### ADDENDUM # 3

#### **Bid 19C14, Rock Creek School Replacement Project**

To: All Plan Holders  
Project: Rock Creek School Replacement  
Walkersville, Maryland  
Re: Addendum #3

P200B

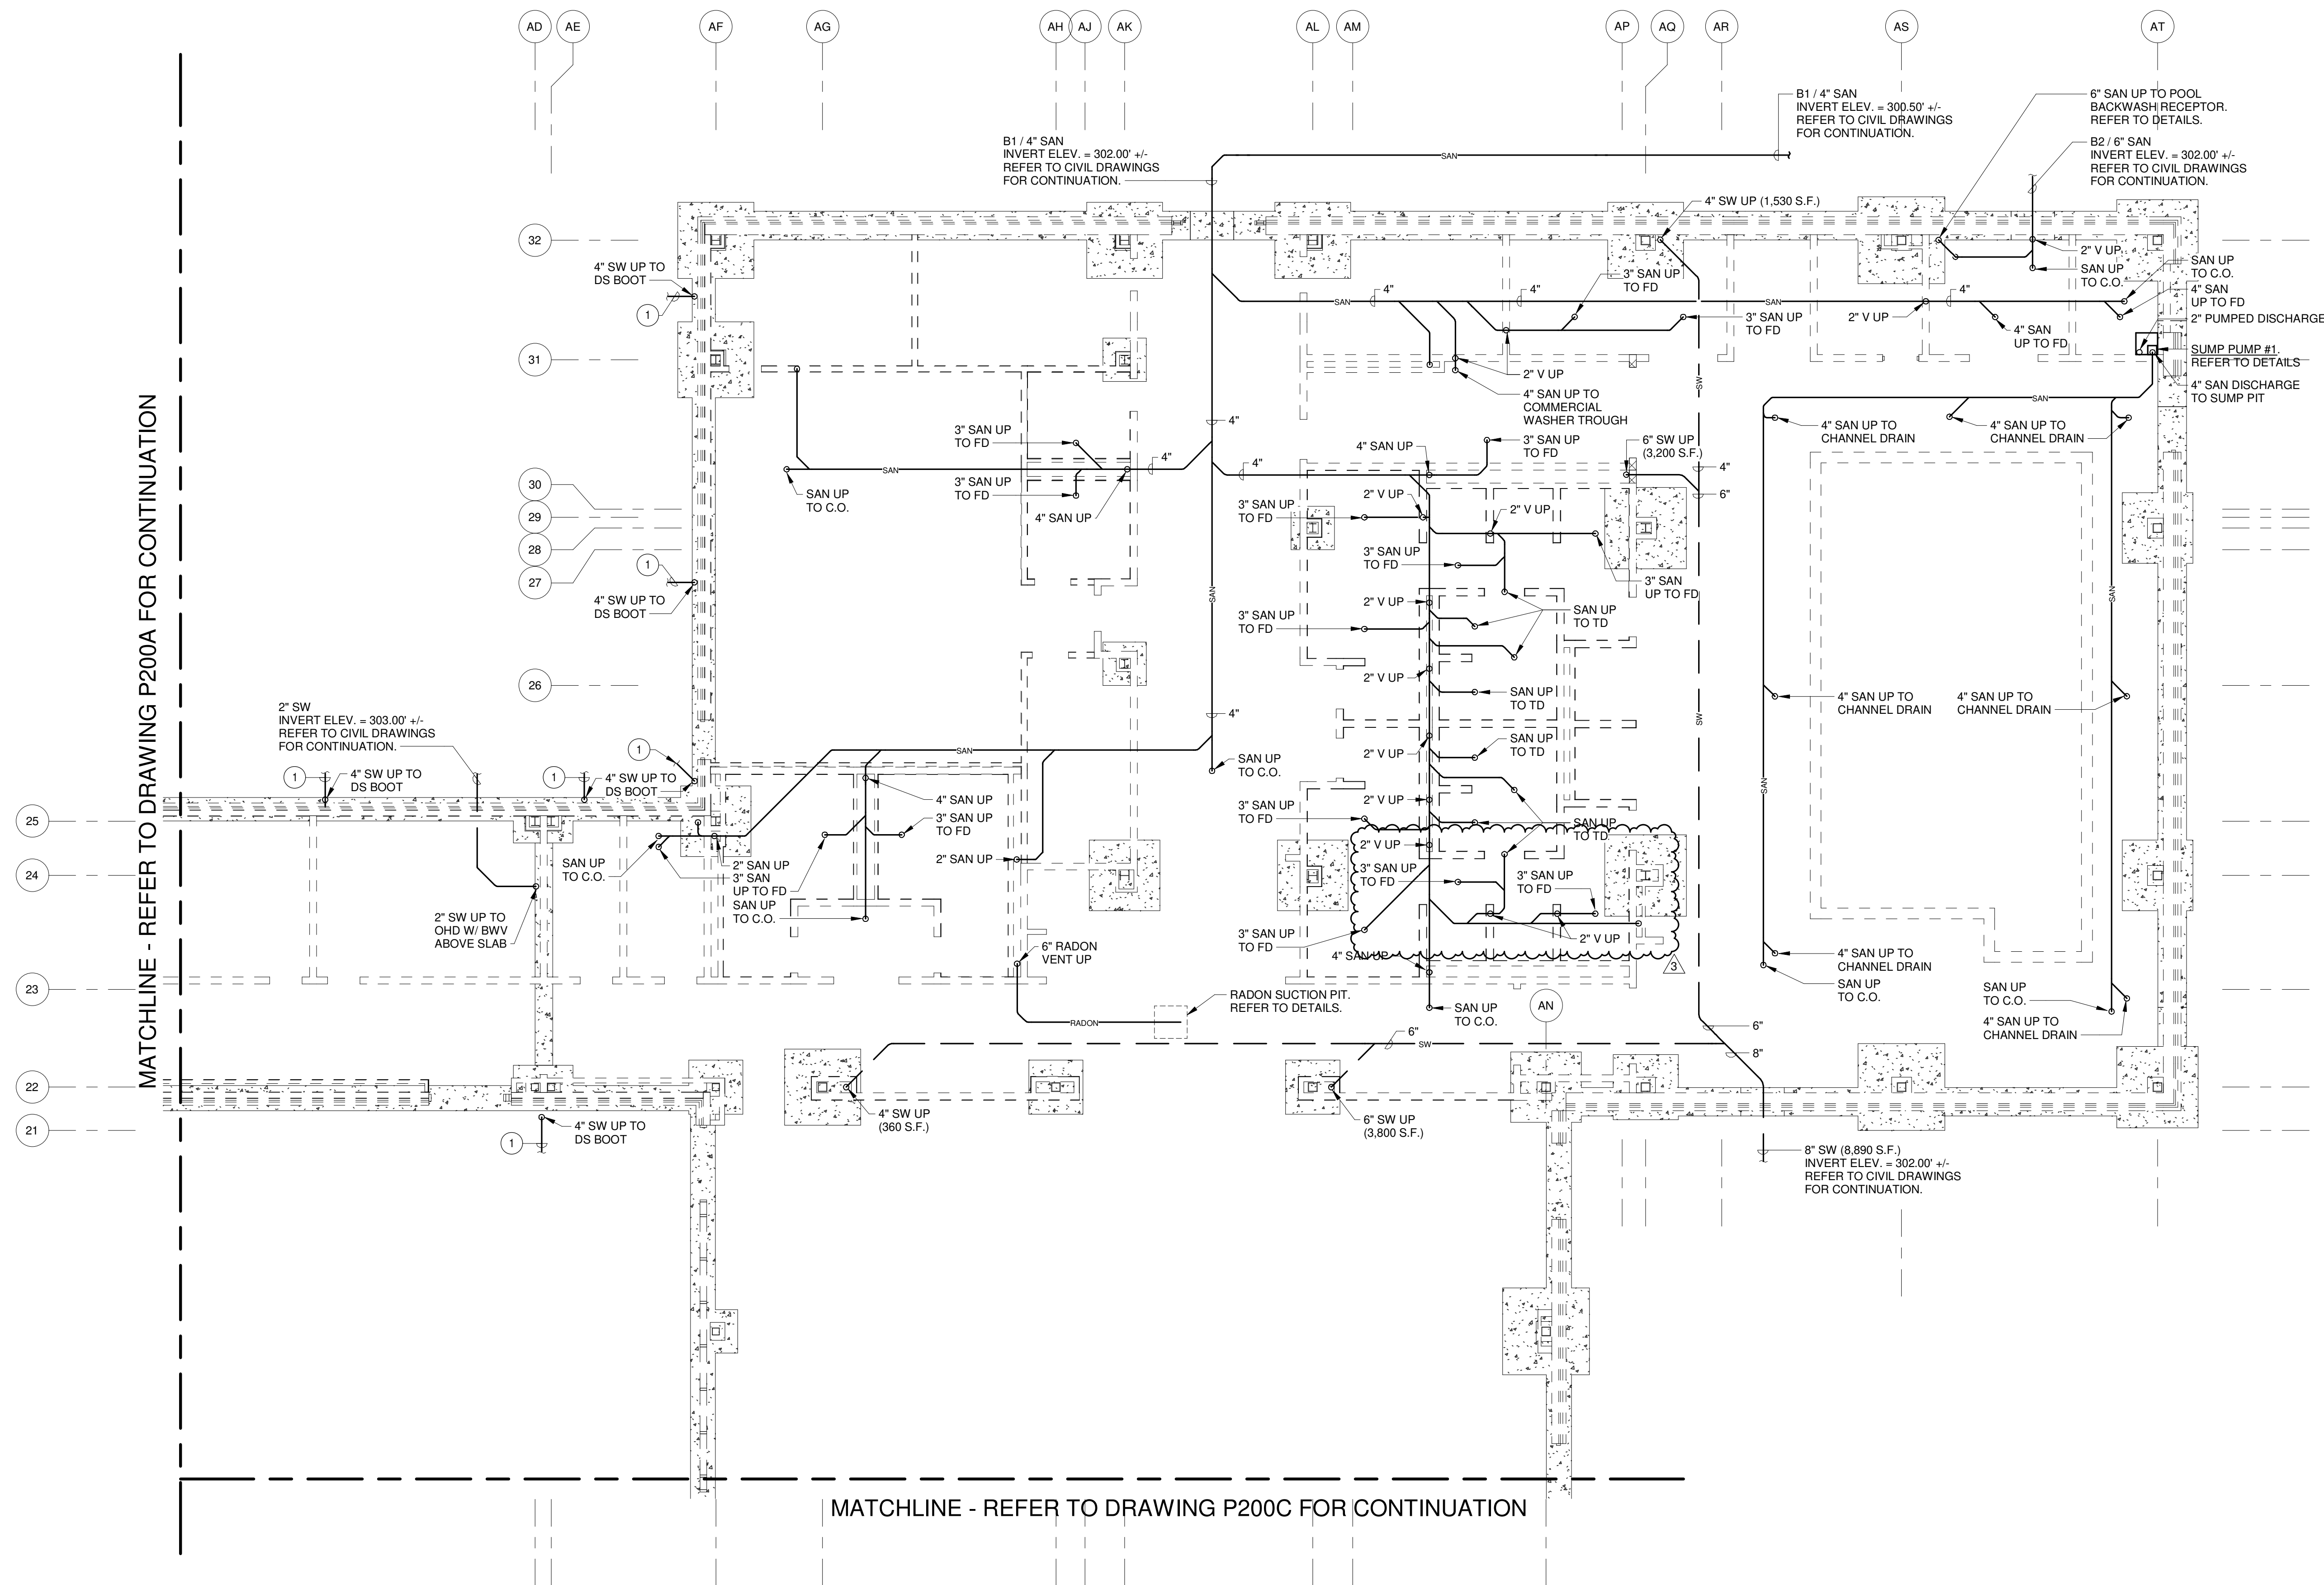
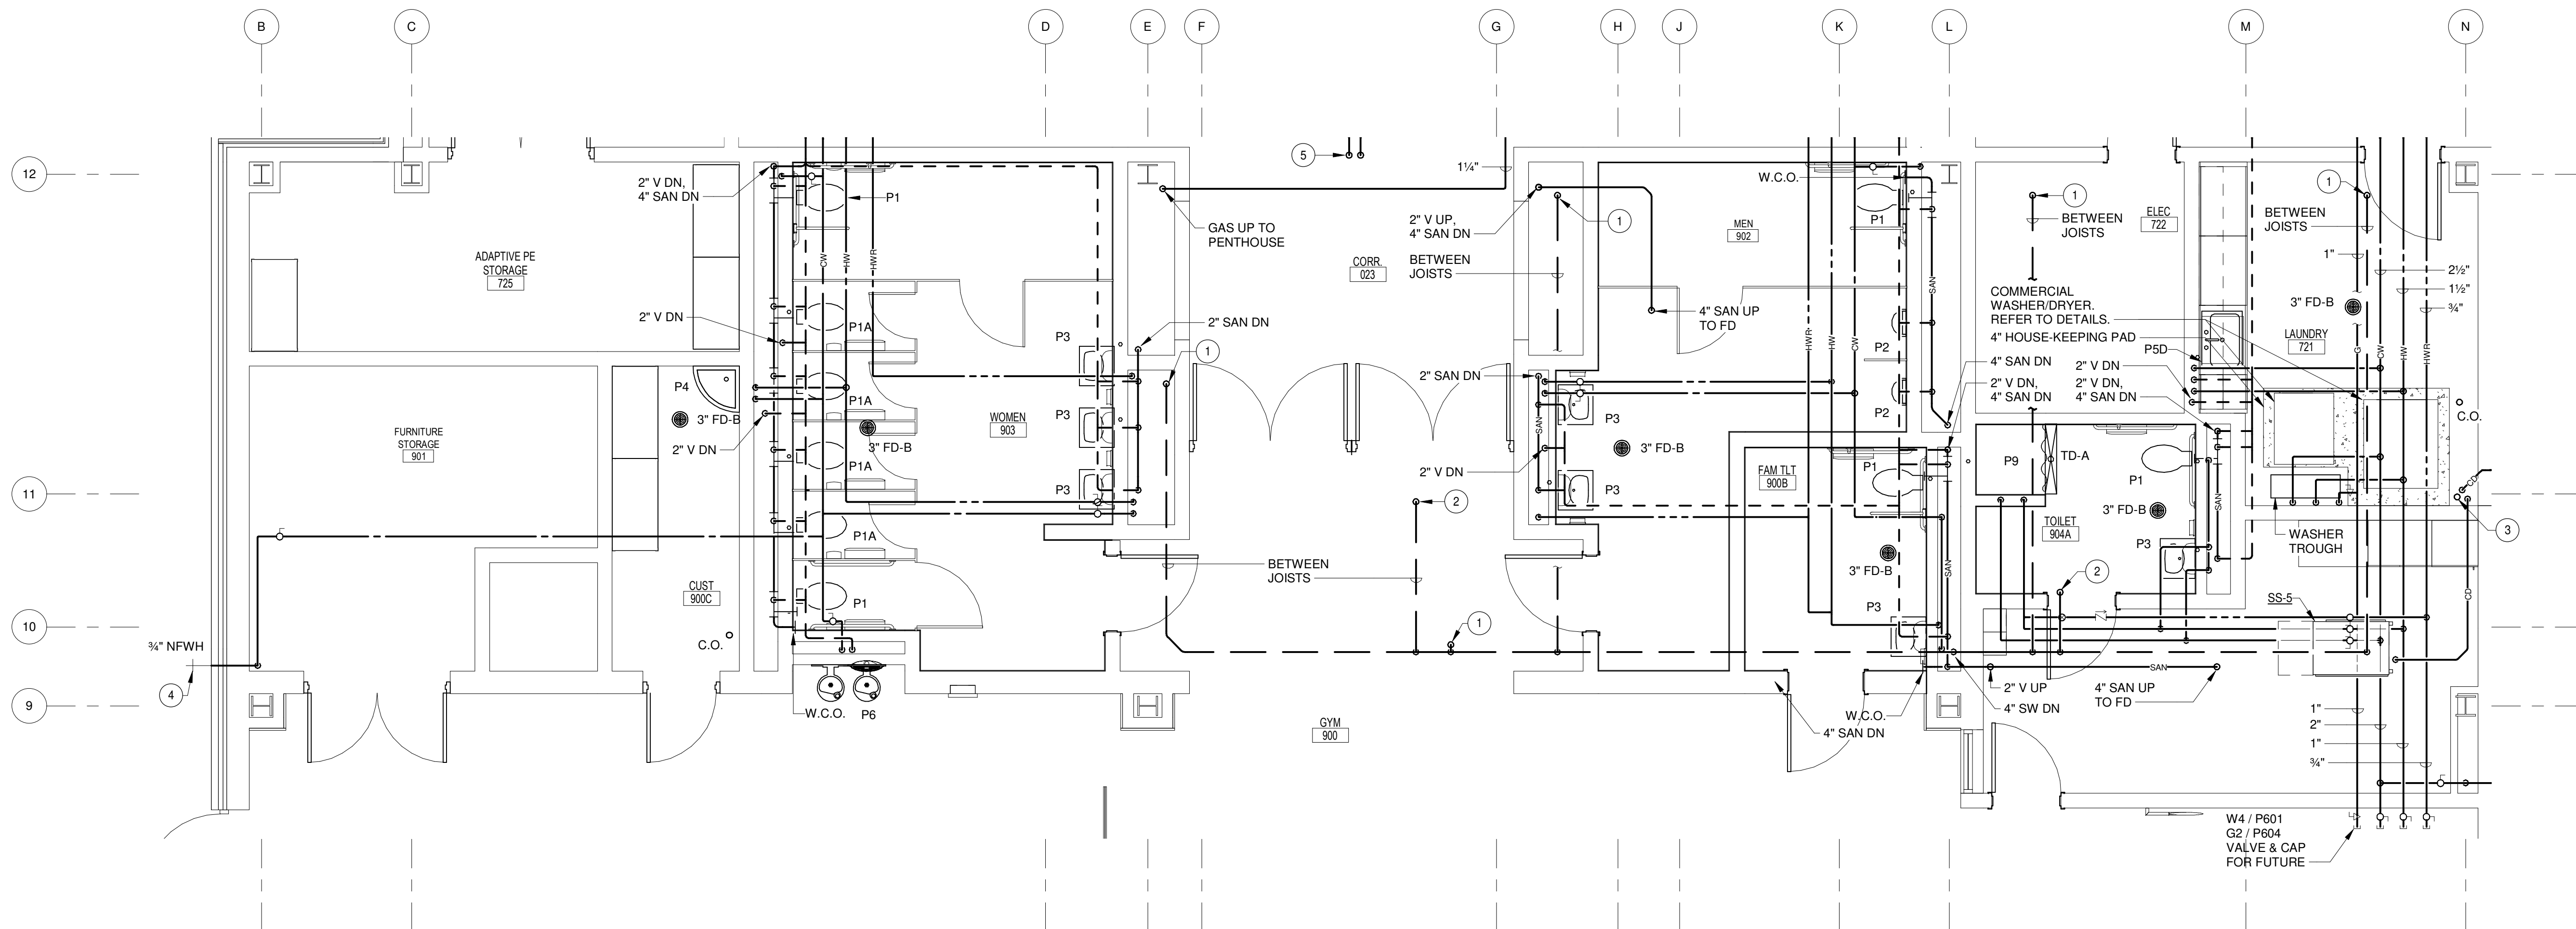
1. **P200B – FOUNDATION PLAN – AREA B**
  - **ADD** - Add sanitary piping serving fixture P6 in room Aquatic 400
  - **ADD** - Add 2" vent piping up serving drain line for TD-A and 3" FD-B in Girls Locker Room 402.

- **REVISE** - Revise sanitary and vent piping layout for drain lines serving Girls Locker Room 402.
2. **P302 – TOILET & LOCKER ROOM PART PLANS**
  - **ADD** - Add fixture P6 on wall adjacent to Girls Locker Room 402 and associated domestic cold water and vent piping.
